Informal document GRPE-83-09 to amend GRPE-2021-18e  
83<sup>rd</sup> GRPE, 01-04 June 2021  
Agenda item 9(a)  
Proposed updates to GRPE/2021/18 are shown via tracked  
changes – unless otherwise specified, with some explanatory  
comments also included.

### Proposal for a new UN GTR on In-vehicle Battery Durability for Electrified Vehicles

#### Submitted by the Informal Working Group on Electric Vehicles and the Environment (EVE)\*

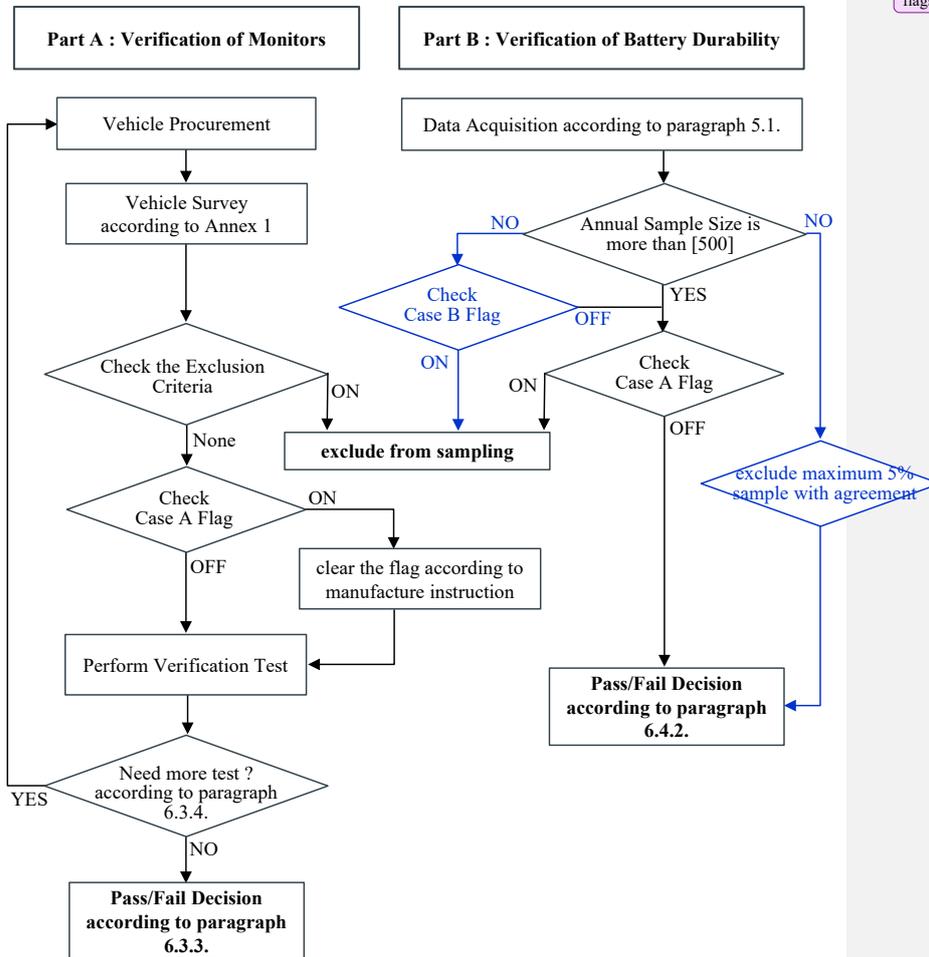
**Commented [DP(1)]:** To evaluate whether this is a simple solution to remove cases B.

**Commented [DP(2)]:** Japan proposes to keep flag A also for Part B evaluation. But take away Flag B.

Commented [DP(3)]: To refine after decisions are taken on the flags.
